February 11, 2013

RE: CIRCLE RESTAURANT  
PERMIT NO. 3PR00120  
PORTAGE COUNTY  
DEERFIELD TOWNSHIP

Figure 3

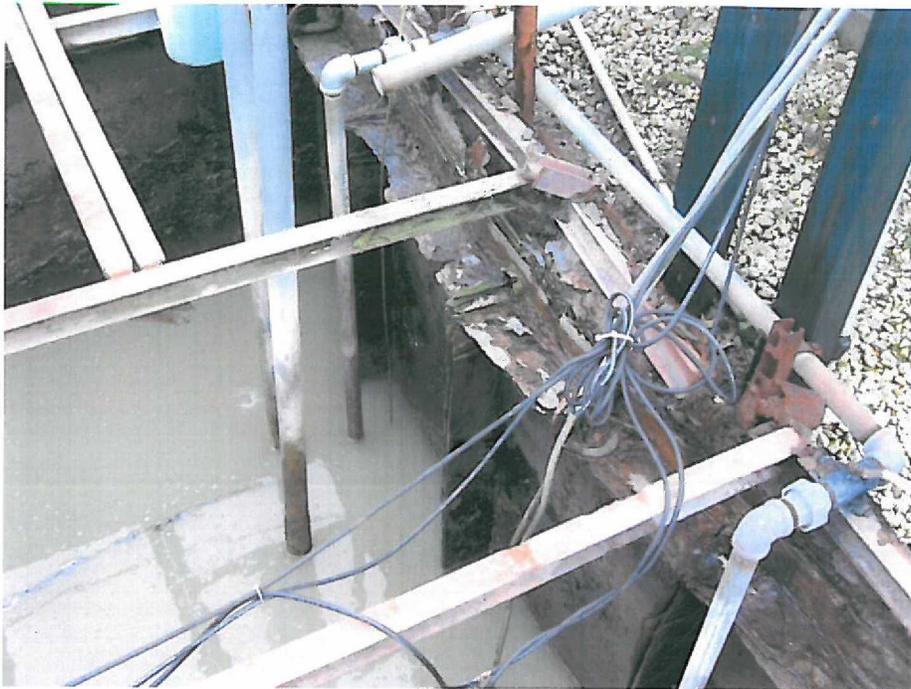
12. Scum build-up/ solids deposition was also present behind the baffle in the settling tank. See Figure 3. This material should be removed on a regular basis.
